In re application of: Patrick K. Egan et al. : Date: June 8, 2000  
Group Art Unit: 2831 : IBM Corporation  
Examiner: K. Cuneo : Intellectual Property Law  
Serial No.: 09/074,213 : Dept. 917, Bldg. 006-1  
Filed: May 7, 1998 : 3605 Highway 52 North  
Title: BACKPLANE POWER : Rochester, MN 55901  
DISTRIBUTION SYSTEM

PROPOSED AMENDMENT TO THE DRAWING

FIGURE 2

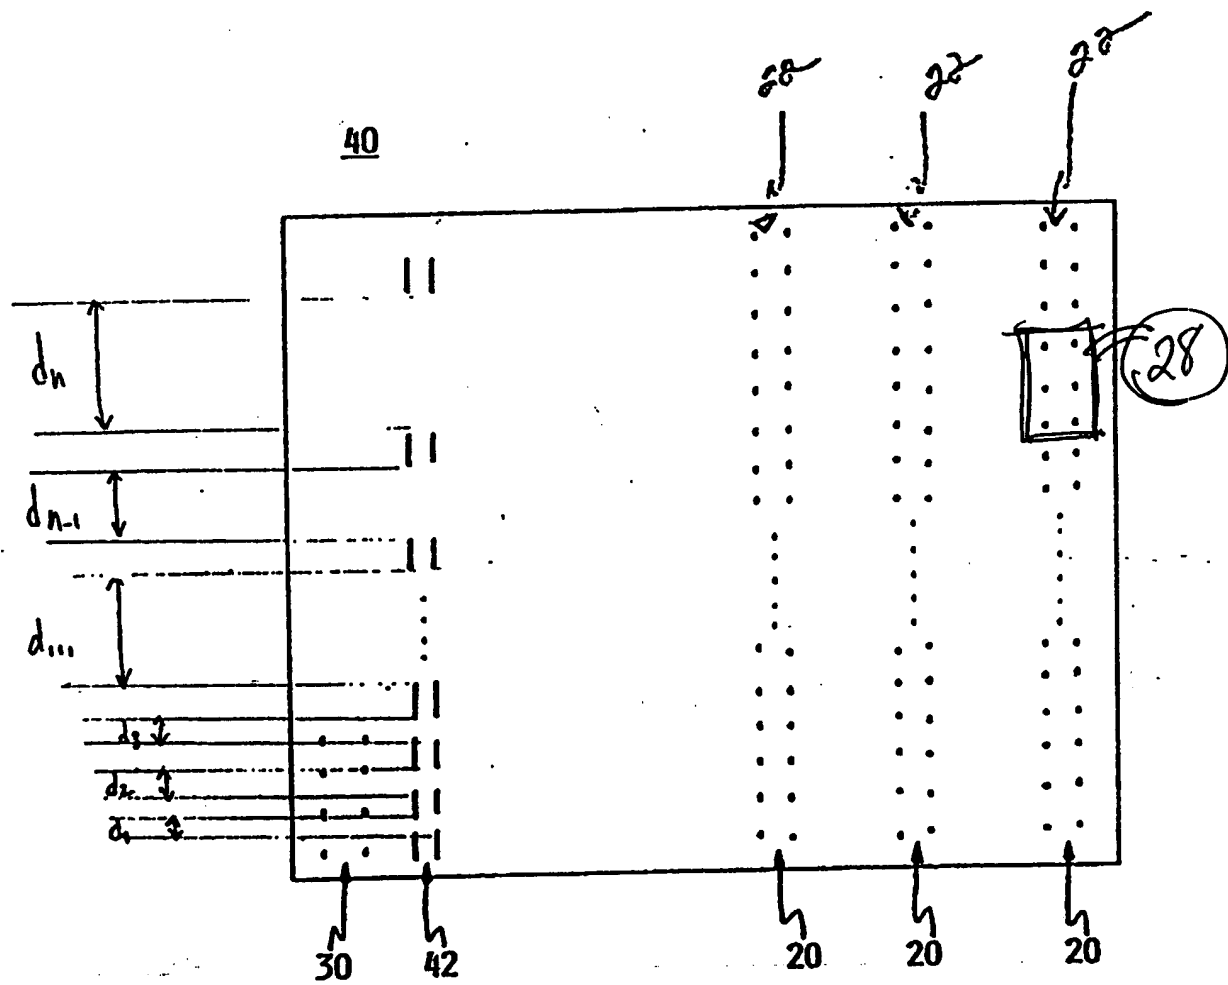
Please insert a rectangular block with a lead line to a reference numeral 28, as shown.

a rectangular block, a pointer, and a reference numeral 28 has been added representing connector straps or pads, wiring networks, etc. as described in the specification at page 4, lines 23-24 and in claim 11.

Figure 3

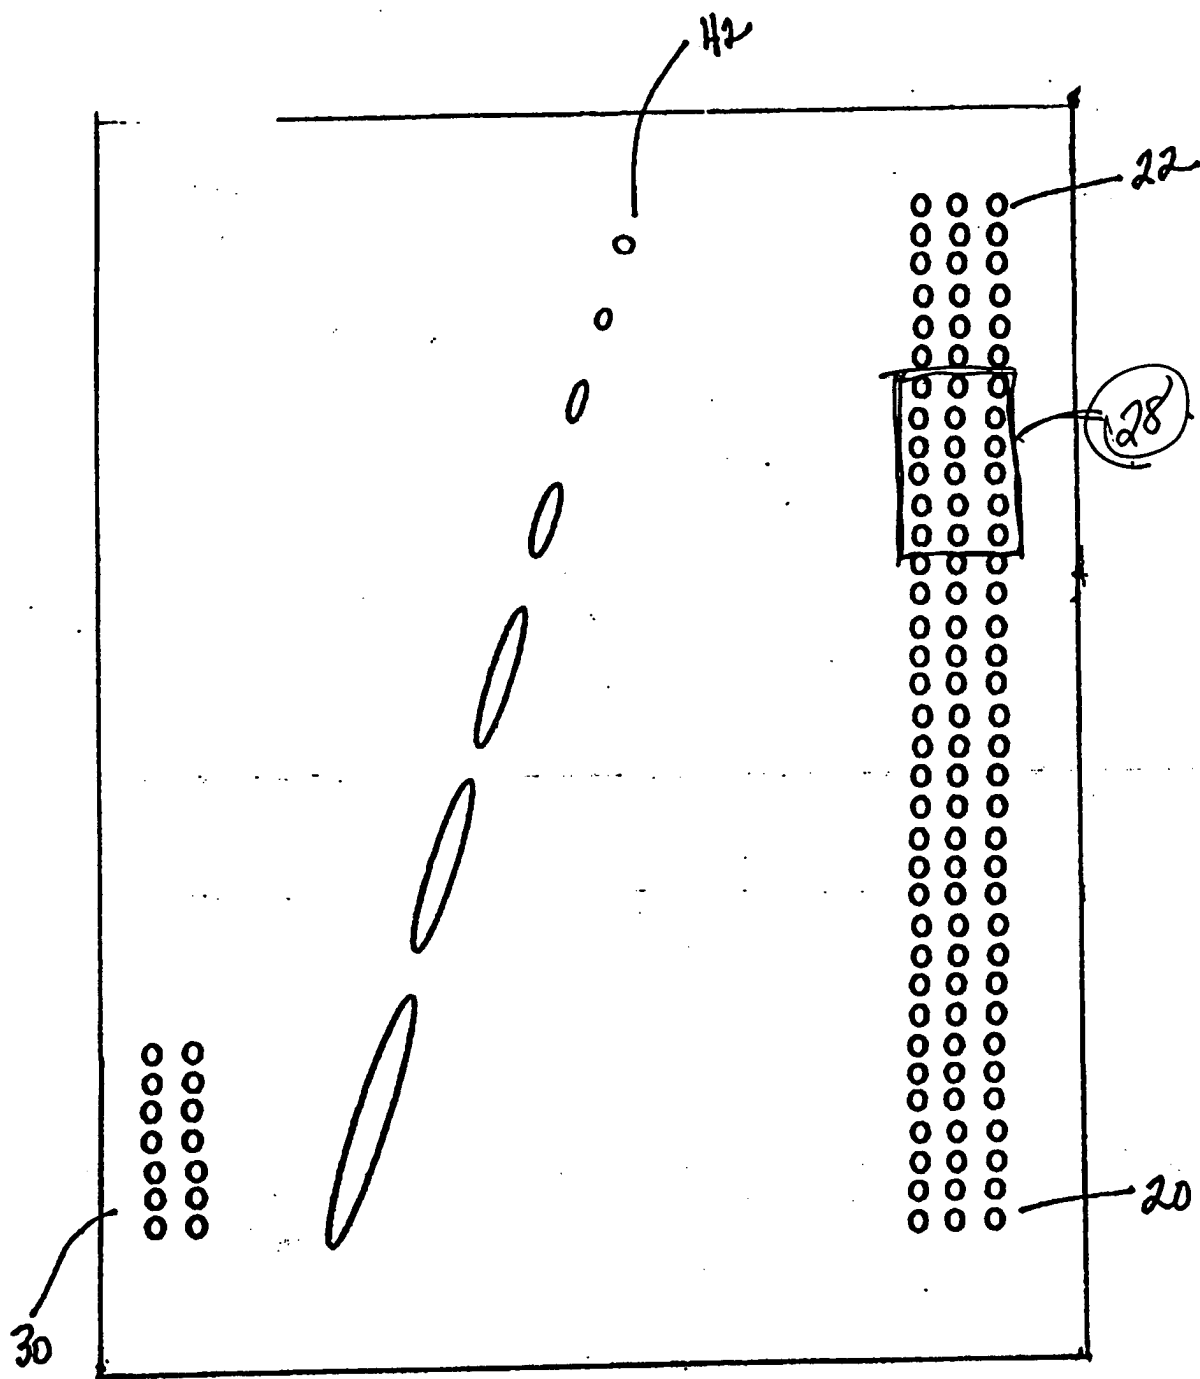
Please insert a rectangular block with a lead line to a reference numeral 28, as shown.

a rectangular block, a pointer, and a reference numeral 28 has been added representing connector straps or pads, wiring networks, etc. as described in the specification at page 4, lines 23-24 and in claim 11.

Figure 4  
Sheet 3 of 4  
Egan et al.  
R0905-122B

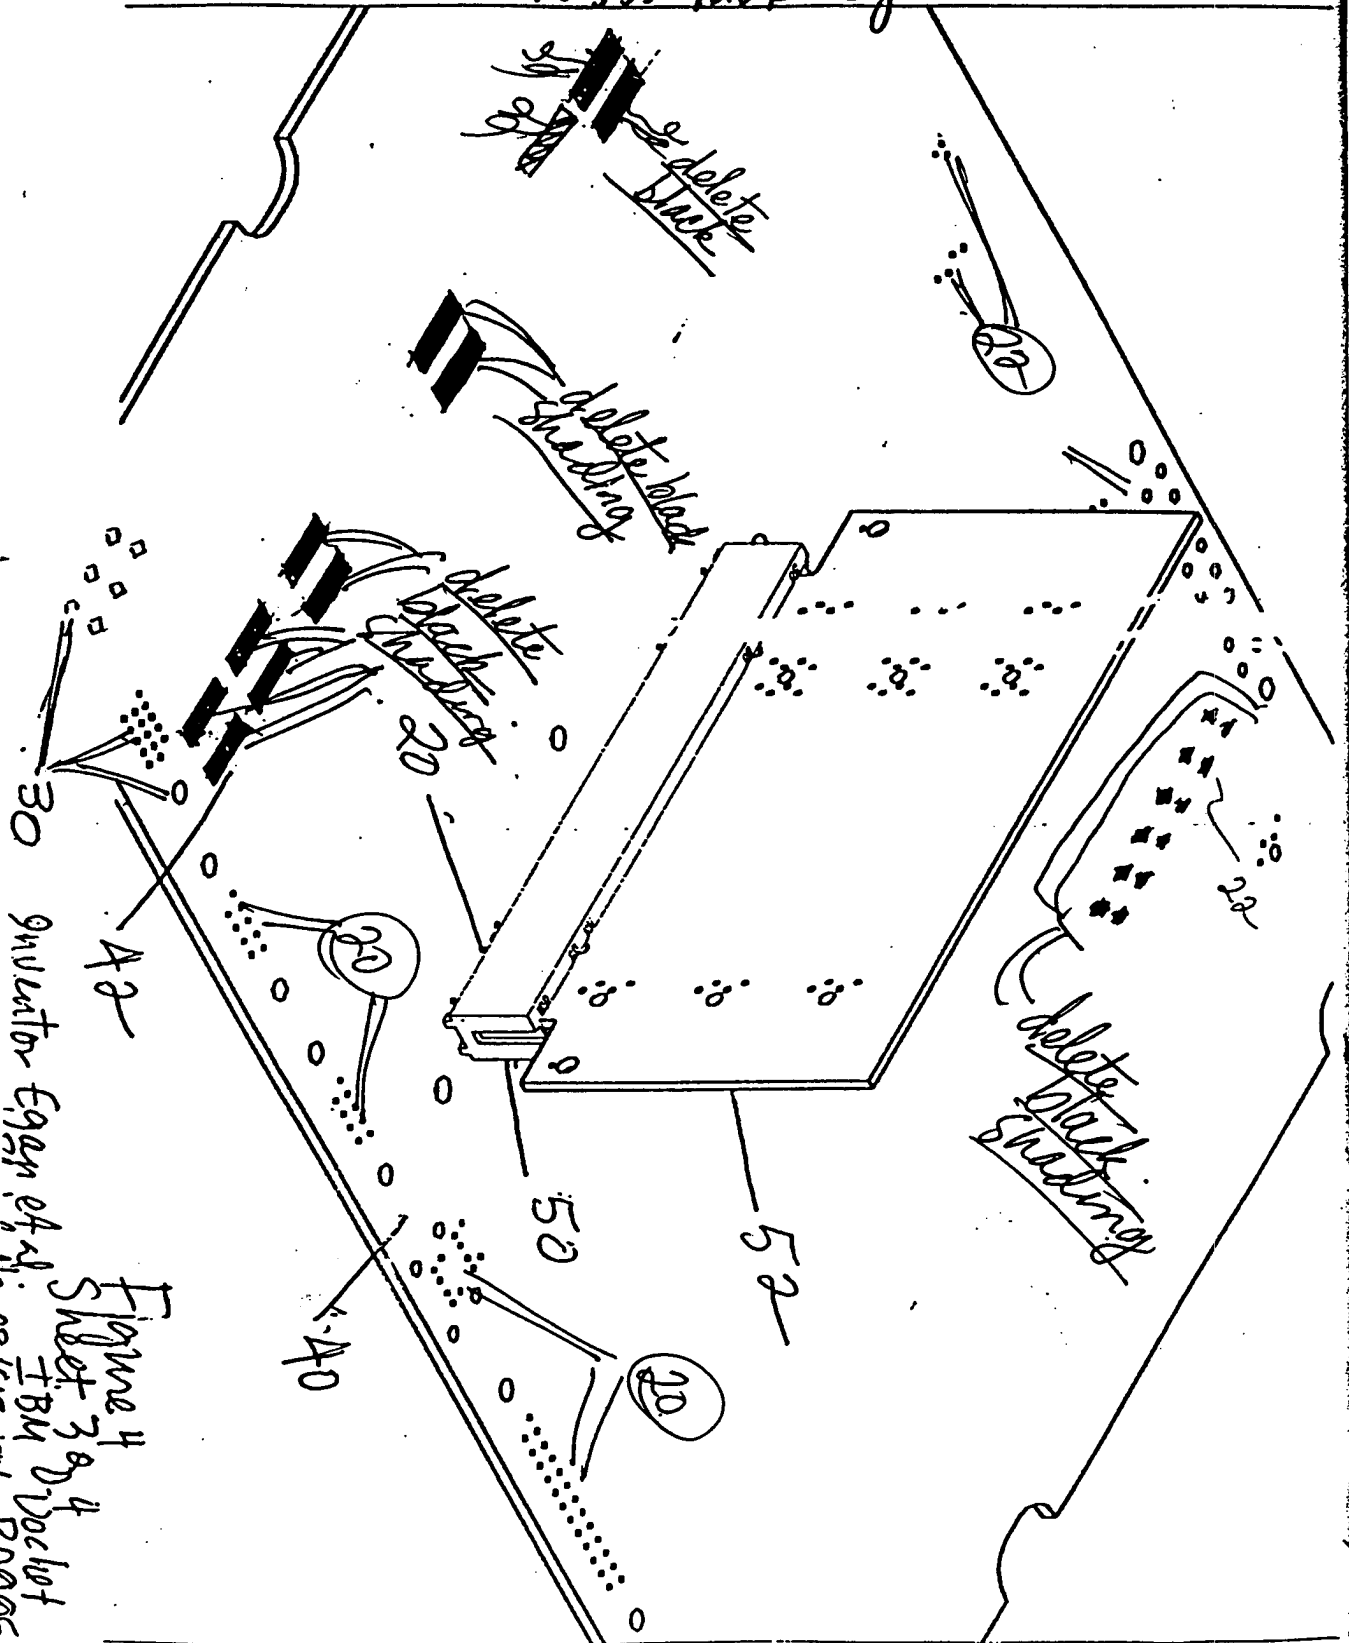
the Examiner states that it is unclear what the shapes of 20 and 22 are.

Please insert and extend the edges of the powerplane 40 so the lower right-hand portion of the figure is not cut off.

Please delete the black shading from the impedance variations 42 at the left third of the page and at the far load locations 22 towards the top of the page, without disclaimer or prejudice.

Please insert lead lines from the reference numeral 20 to the holes on powerplane as indicated.

Please insert lead lines from the reference numeral 22 to the holes on powerplane as indicated.

Please insert lead lines from the reference numeral 30 to the holes on powerplane as indicated.

the edges of the powerplane 40 have been inserted and extended so that the lower right-hand portion of the figure is not cut off;

the coloring of the impedance variations and load locations of Figure 4 has been deleted. In doing so, however, Applicants maintain that the impedance variations 42 are not limited to the geometric openings presented but can be openings of different shapes and/or material of different resistivity than that of powerplane 40;

pointer lines have been inserted from reference numerals 20, 22, and 30 to the different holes on the powerplane;

the Examiner states that it is unclear what the shapes of 20 and 22 are. Respectfully, the specification states that the source locations (30) and load locations (20 and 22) be capable of receiving pins. The shape of the pins is not disclosed in the specification and it is known in the art that connector pins come in all kinds of shapes; circular, oval, octagonal, flat, etc. Applicants respectfully decline to limit the invention to a particular rendition and maintain that the source locations and the load locations are the same part as referenced in Figures 2, 3, and 4.
